Model: Sh-MF1	Date: 10-Aug-11	No.: RM052001c
---------------	-----------------	----------------

Subject: Firmware Release Note: Fax		Prepared by: T. Tachibana	
From: 1st Tech Service Sect., MFP/Printer Tech Service Dept.			
Classification:	<input type="checkbox"/> Troubleshooting <input type="checkbox"/> Mechanical <input type="checkbox"/> Paper path <input type="checkbox"/> Product Safety	<input type="checkbox"/> Part information <input type="checkbox"/> Electrical <input type="checkbox"/> Transmit/receive <input checked="" type="checkbox"/> Other (Firmware)	<input type="checkbox"/> Action required <input type="checkbox"/> Service manual revision <input type="checkbox"/> Retrofit information <input checked="" type="checkbox"/> Tier 2

Model: Sh-MF1		Date: 09-Nov-11	No.: RM052023
Subject: CPU and firmware Change Notification		Prepared by: T.Hirai	
From: 3rd Tech Service Sect., MFP/P Tech Service Dept.			
Classification:	<input type="checkbox"/> Troubleshooting <input type="checkbox"/> Mechanical <input type="checkbox"/> Paper path <input type="checkbox"/> Product Safety	<input checked="" type="checkbox"/> Part information <input type="checkbox"/> Electrical <input type="checkbox"/

**6.ADF Section 2 (M052/M053/M054)**

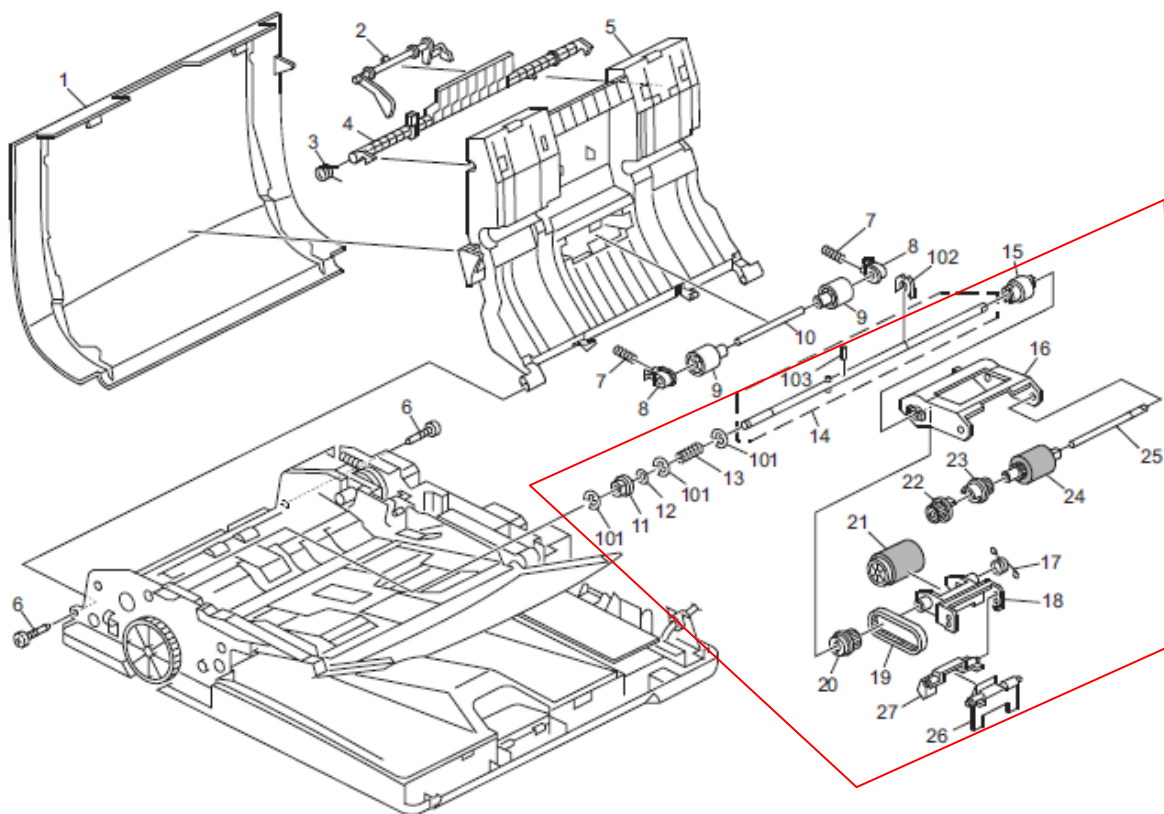
**Change/Reason:** The following part number was added.

Incorrect part number	Correct part number	Description	Q'ty	Int	Note
-	M3642100	Paper Feed Roller Assembly	1	-	*1

M3642100 includes the following parts index #11 to #27, P20.

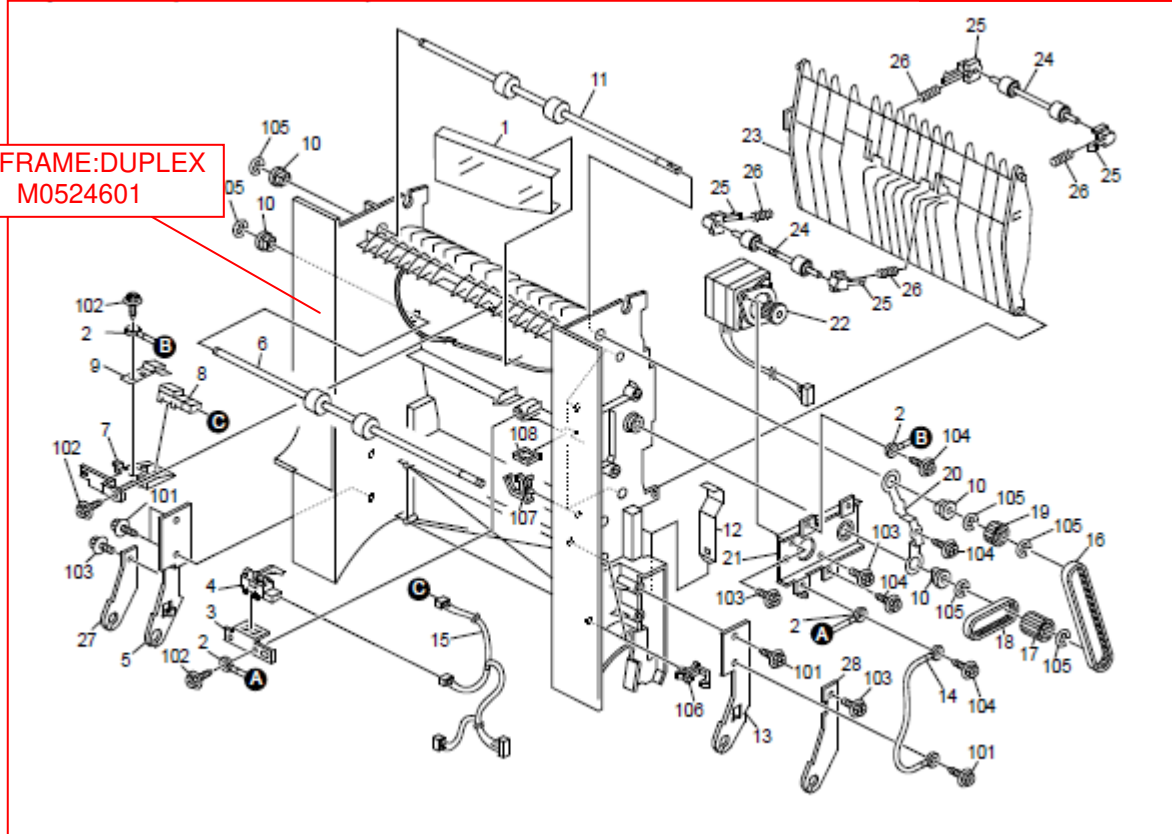
**Change/Reason:** The following part number and index number was added.

Incorrect part number	Correct part number	Description	Q'ty	Index	Note
-	M0520250	DUPLEX UNIT:UPPER:MF	1	29	
-	M0524601	FRAME:DUPLEX	1	30

## 5.ADF Section 1 (M052/M053/M054)

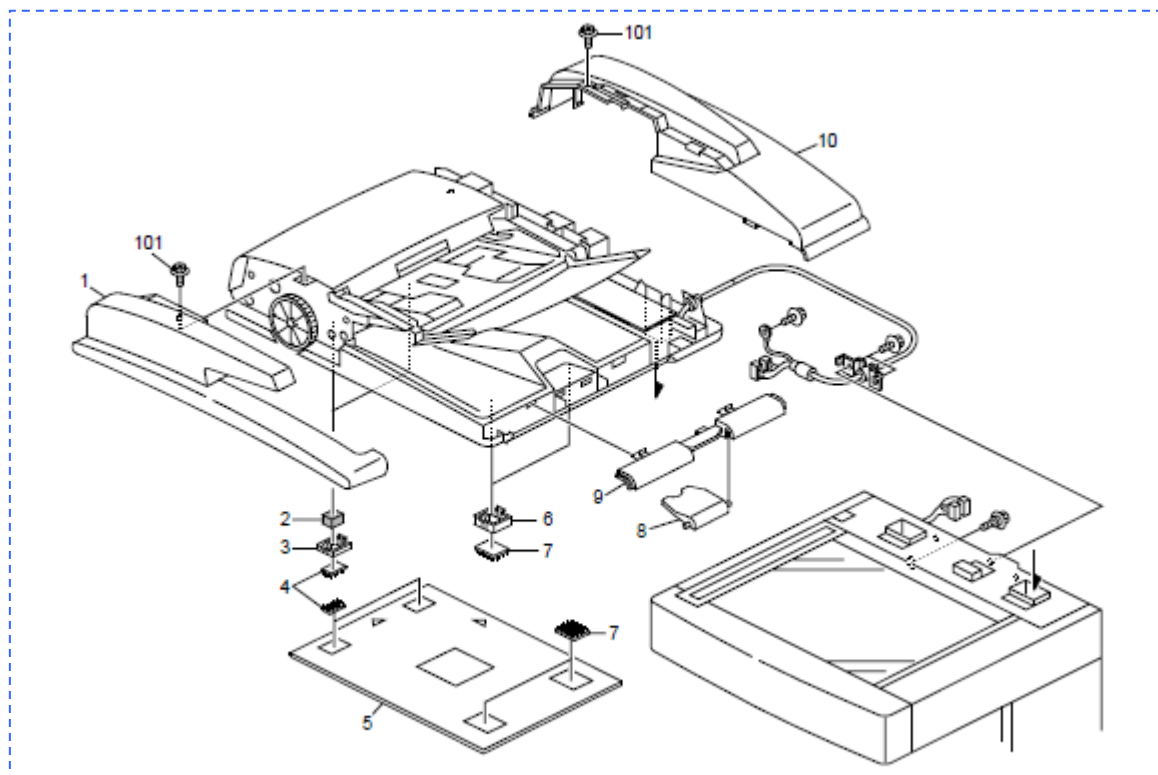
**Change/Reason:** The following parts number and index number were changed.

Incorrect part number	Correct part number	Description	Q'ty	Page	Index	Note
-	M3640090	ADF:MARCY:GER:ASS'Y	1	19	11	-

## 18.Paper Tray (M052/M053/M054)

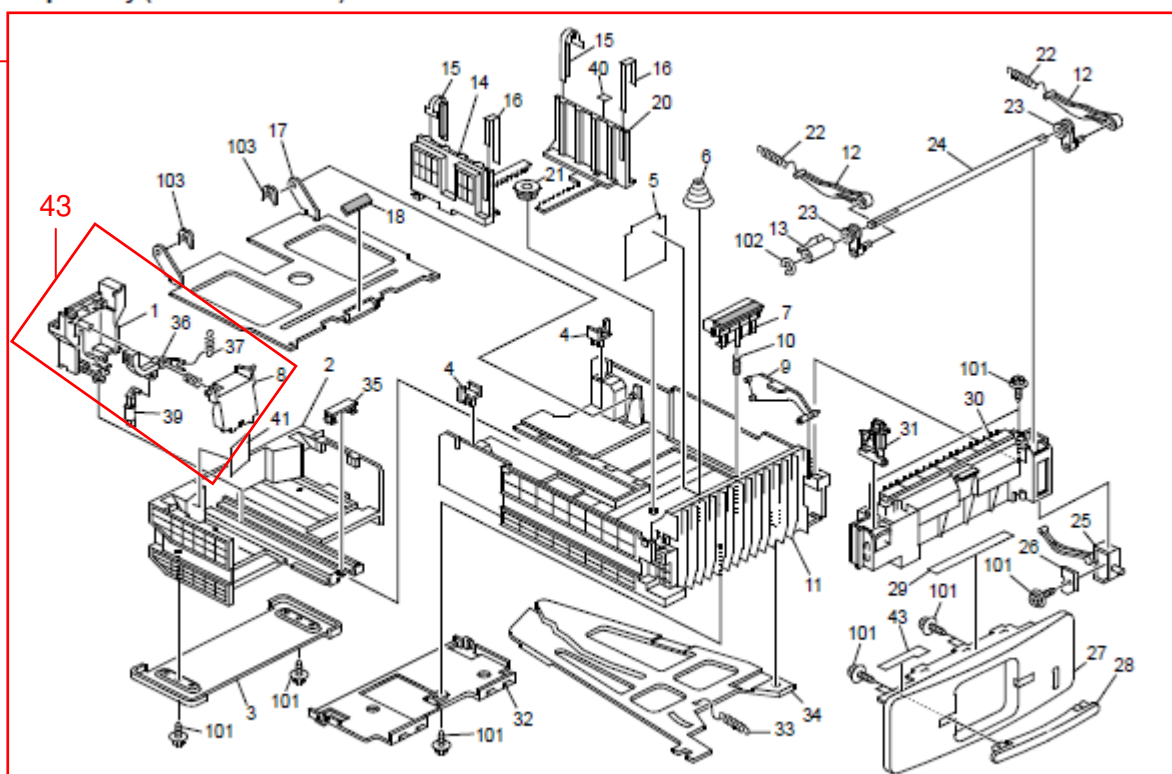
**Change/Reason:** The following part numbers and index numbers were changed.

Incorrect part number	Correct part number	Description	Q'ty	Page	Index	Note
M0522605	<b>M0212605</b>	Feeler Paper Volume Bottom Plate Tray	1	45	9	
M0212657	<b>M0212658</b>	Tray Bottom Plate	1	45	17	
G5553069	<b>M0212657</b>	Pad: Bottom Plate: Tray	1	45	18	
08050089	-	Retaining Ring – M4	1	45	19	Note.1
-	<b>M0522560</b>	End Fence :Ass'y	1	45	43	
-	<b>M0520130</b>	Feed :MF :Unit	1	45	*

18. Paper Tray (M052/M053/M054)

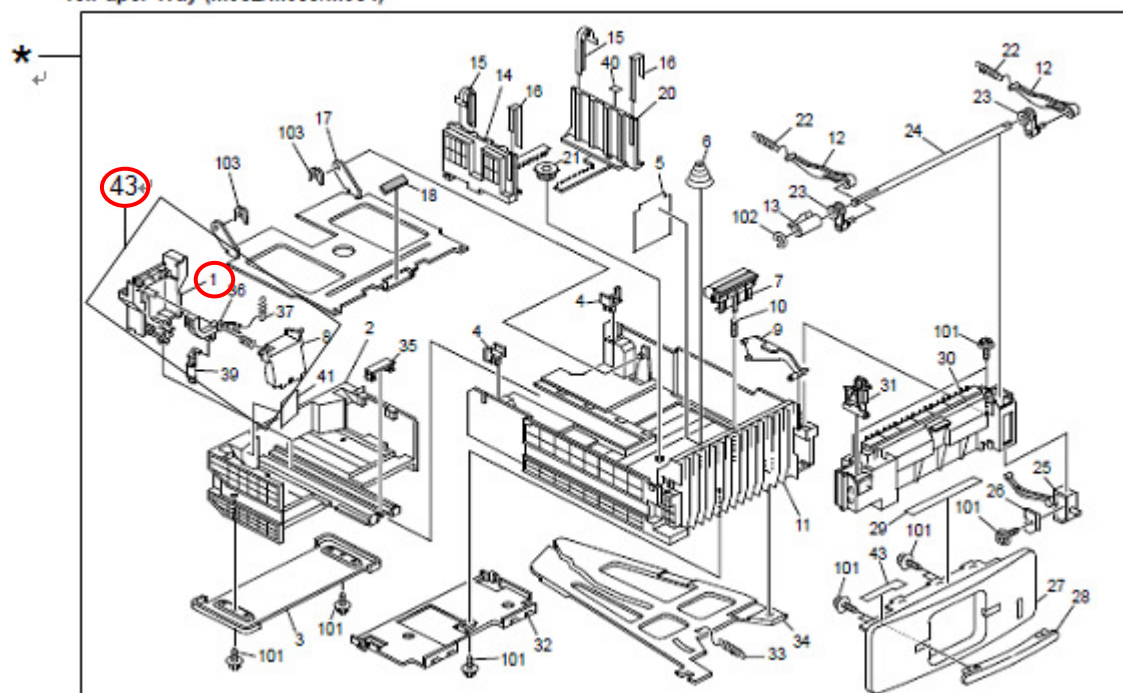
The spring hook for the END FENCE:BASE (M0212565) breaks, which weakens the locking mechanism. As a result, the paper cannot be properly secured in place.

Part Number	Description	Q'ty	Page	Index	Note
<b>M0212565</b>	END FENCE:BASE	1	45	1	
<b>M0522560</b>	END FENCE:ASS'Y	1	45	43

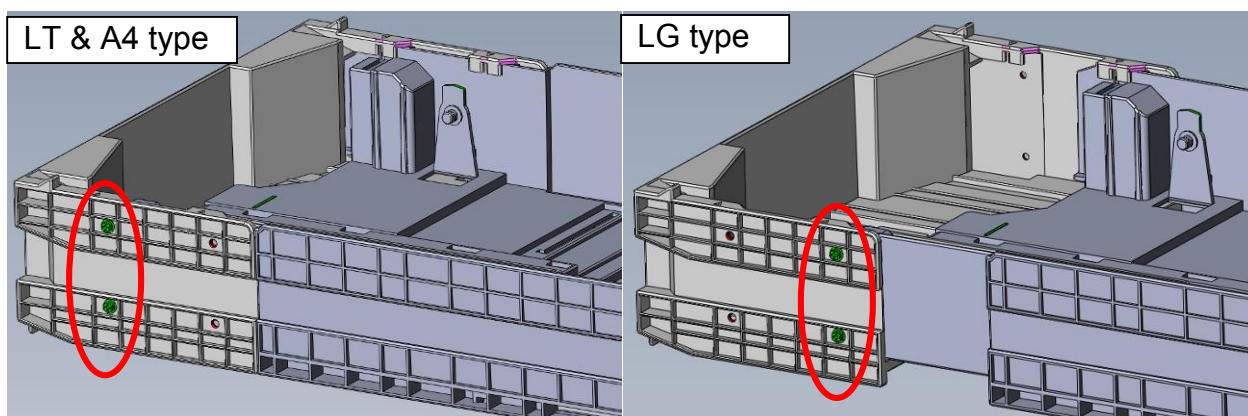
The shape of the stopper was changed, and four screw holes were added so that the extension tray can be fixed in place for LT/A4 and LG paper sizes.

**Important:** *If there is no available screw hole in the user's tray, replace the tray with the following part (which contains the required screw holes).*

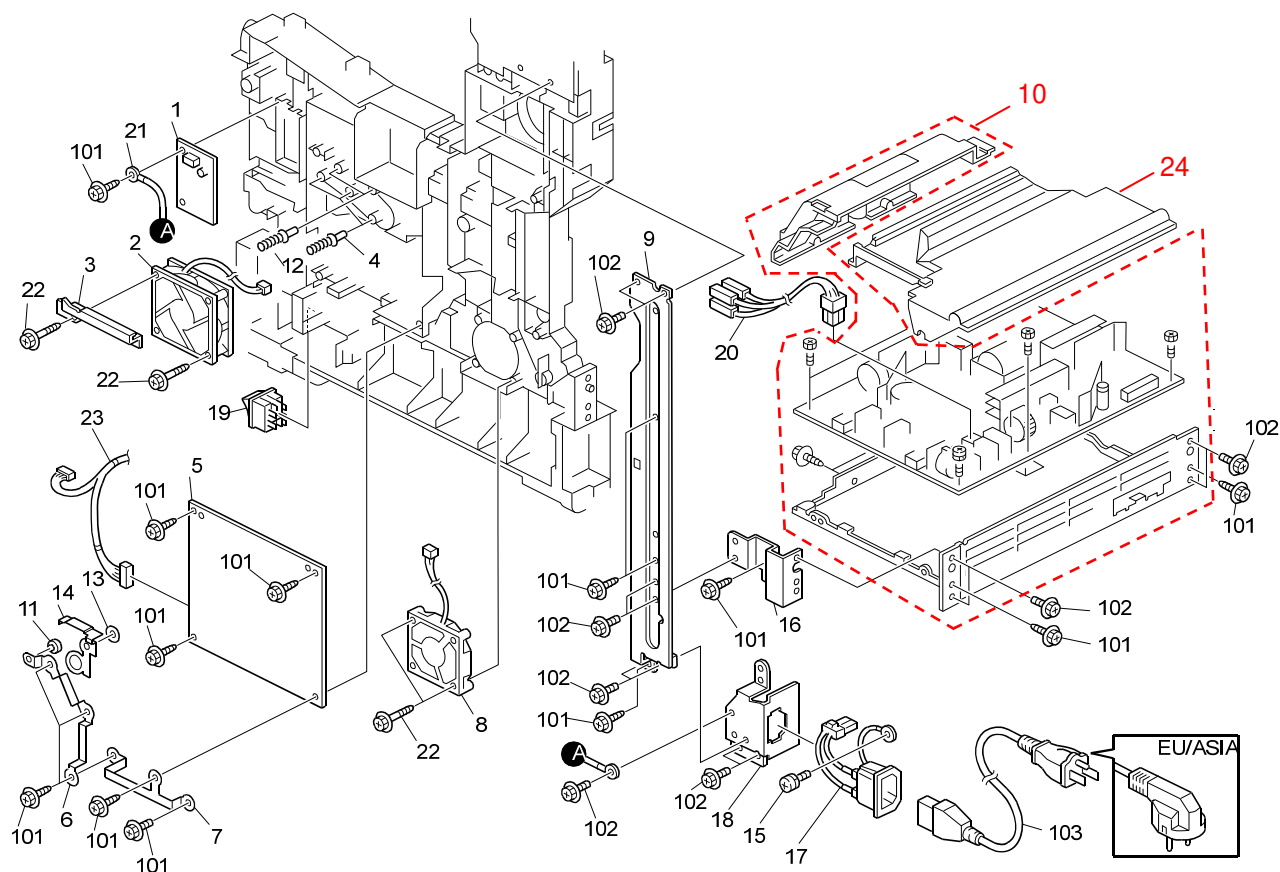
**Change:** The illustration was corrected as follows.

## 19. Paper Feed 1 (M052/M053/M054)

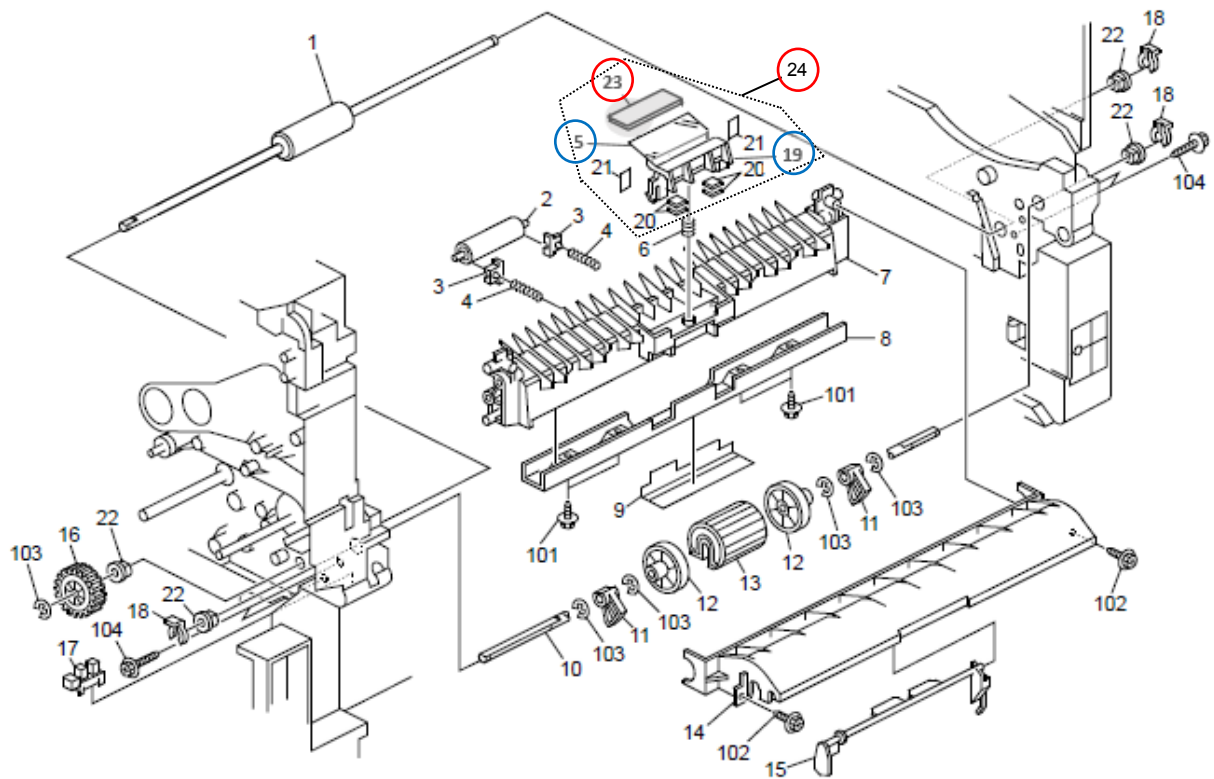
Incorrect part number	Correct part number	Description	Q'ty	Int	Page	Index	Note
M0212711	M0212712	SHEET:HOLDER:FRICTION PAD:MANUAL FEED	-	-	47	5	
M0212712	M0212711	HOLDER:FRICTION PAD:MANUAL FEED	-	-	47	19

## 24.Fusing Unit 1 (M052/M053/M054)

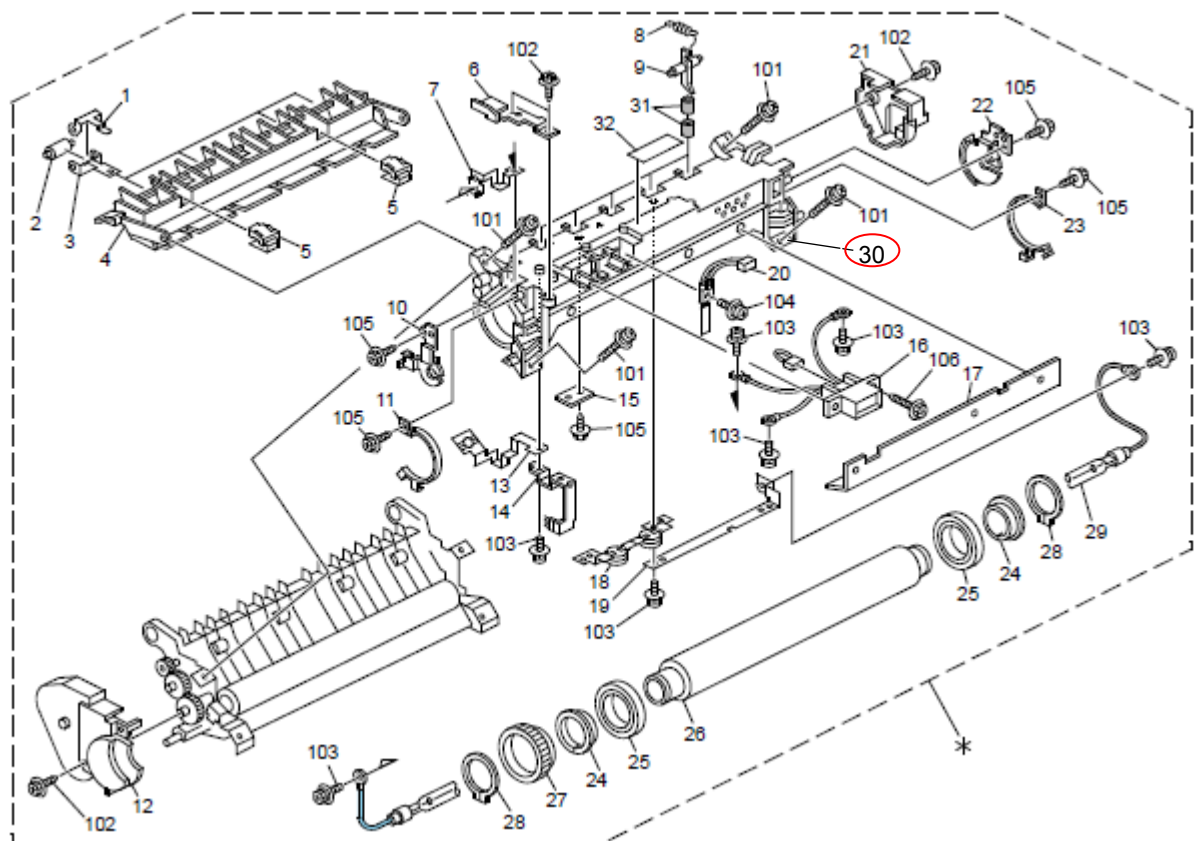
**Change/Reason:** Index #30 was added (it was missing from the illustration).

## 42.Electrical Section 1 (M052/M053/M054)

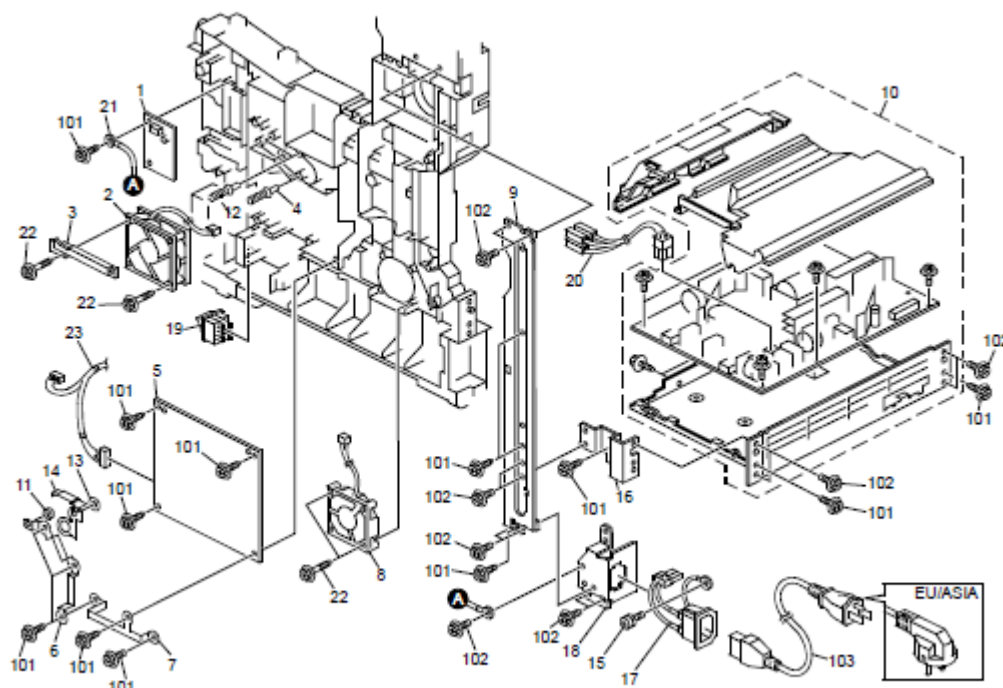
**Change:** The shape of the feeler was changed.

**Change/Reason:** The parts in the table had not been correctly registered in the system.

18.Paper Tray (M052/M053/M054)

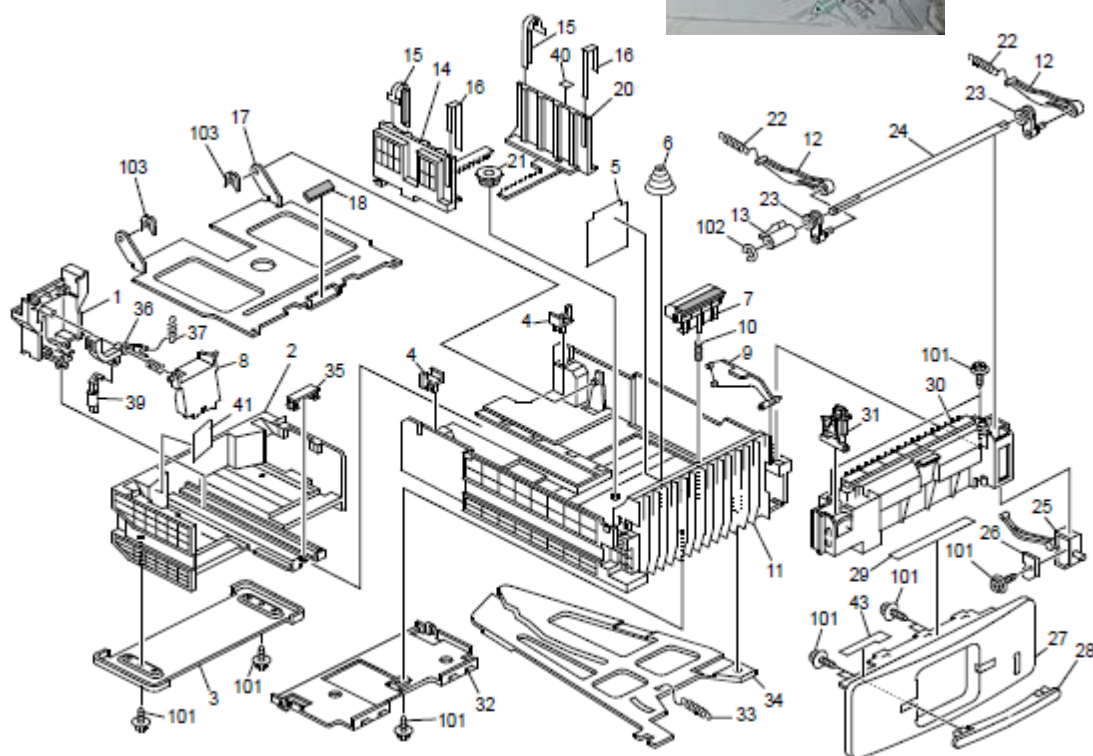
Old part number	New part number	Description	Q'ty	Page	Index	Note
-	<b>M0212608</b>	DECAL:OPERATE:END FENCE	1	46	46

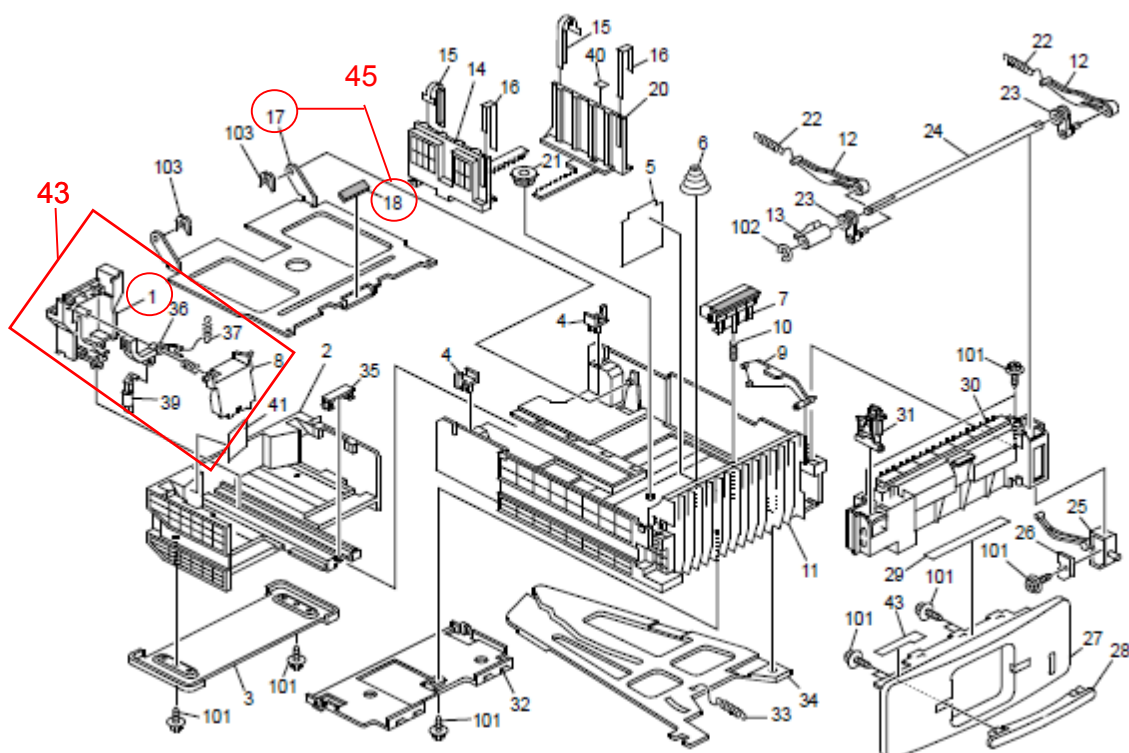
- 1) To increase the adhesive strength of the pad (#18).
- 2) To ensure that the end fence assembly (#43) stays properly attached to the paper size sensing tray (#34).
